ST. LUCIE PLANT UNIT NO. 1

AMENDMENT TO FACILITY OPERATING LICENSE

Amendment No.145  
License No. DPR-67

ATTACHMENT TO LICENSE AMENDMENT NO. 145

FIGURE 2.1-1: REACTOR CORE THERMAL MARGIN SAFETY LIMIT - FOUR REACTOR COOLING PUMPS OPERATING

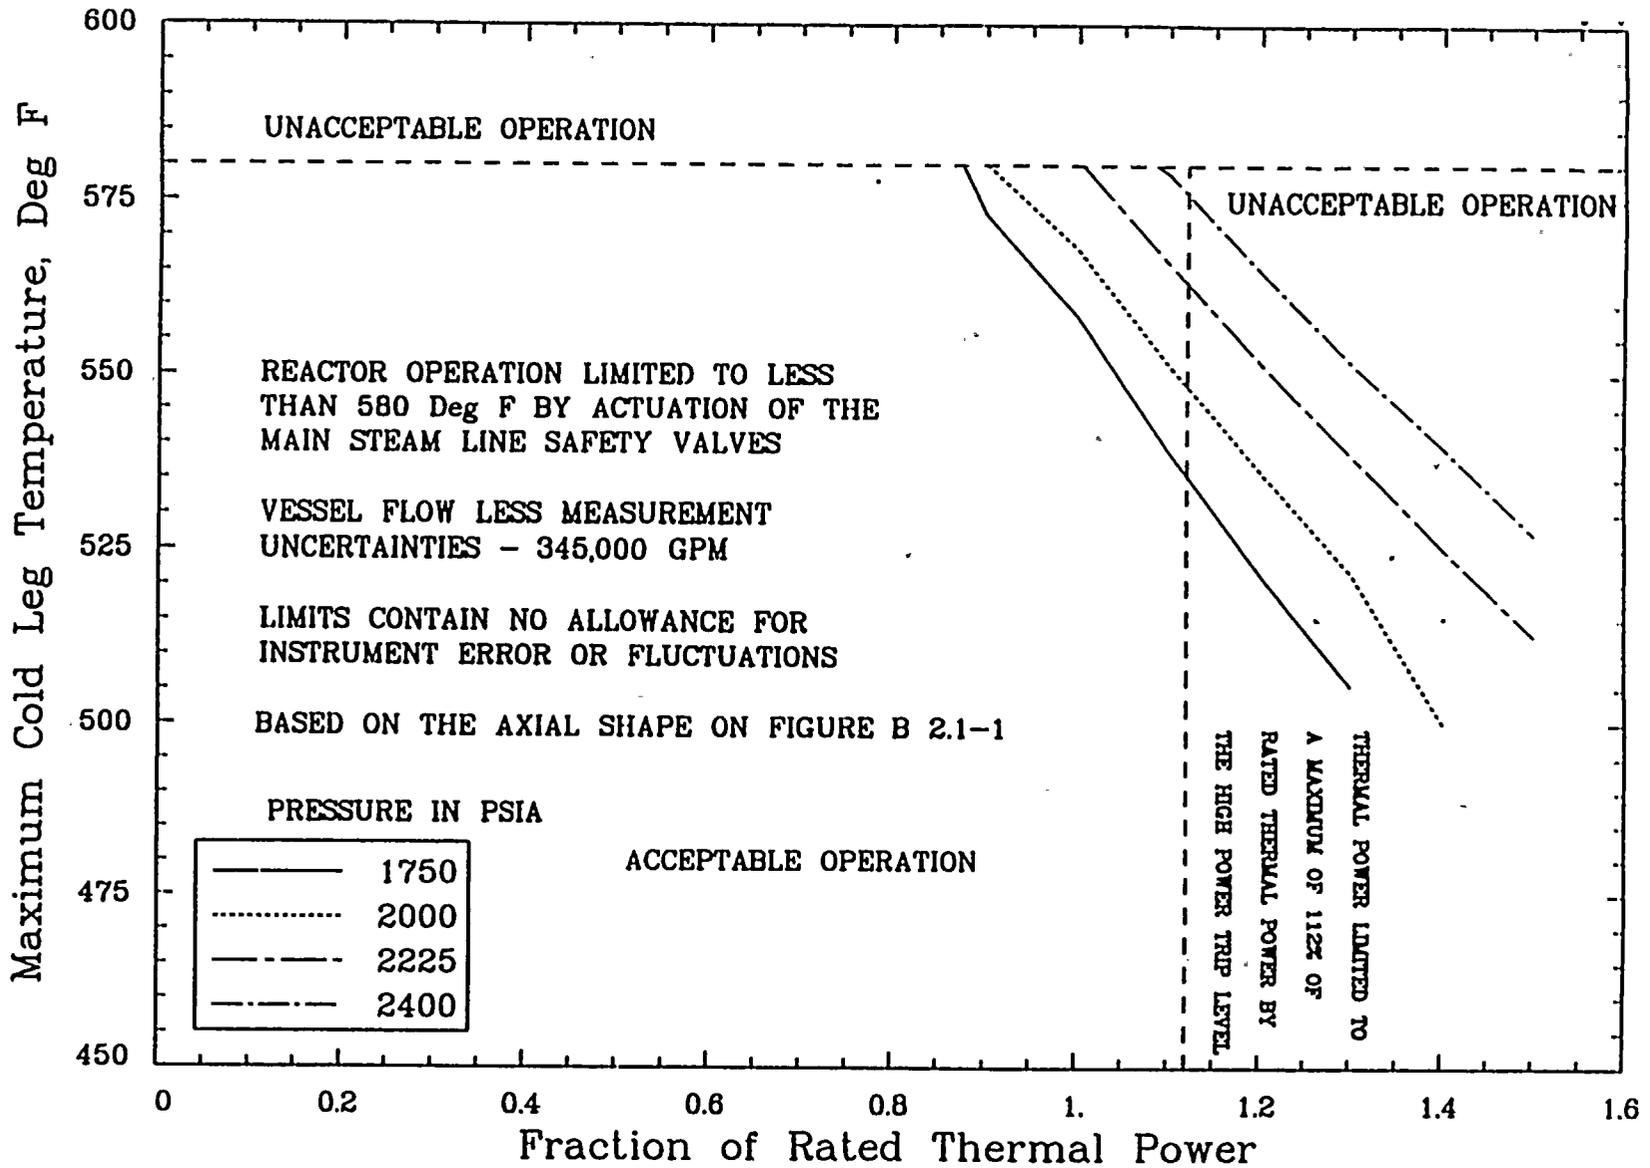
2.1.1 The combination of THERMAL POWER, pressurizer pressure, and maximum cold leg coolant temperature shall not exceed the limits shown on Figure 2.1-1.

Whenever the point defined by the combination of maximum cold leg temperature and THERMAL POWER has exceeded the appropriate pressurizer pressure line, be in HOT STANDBY within 1 hour.
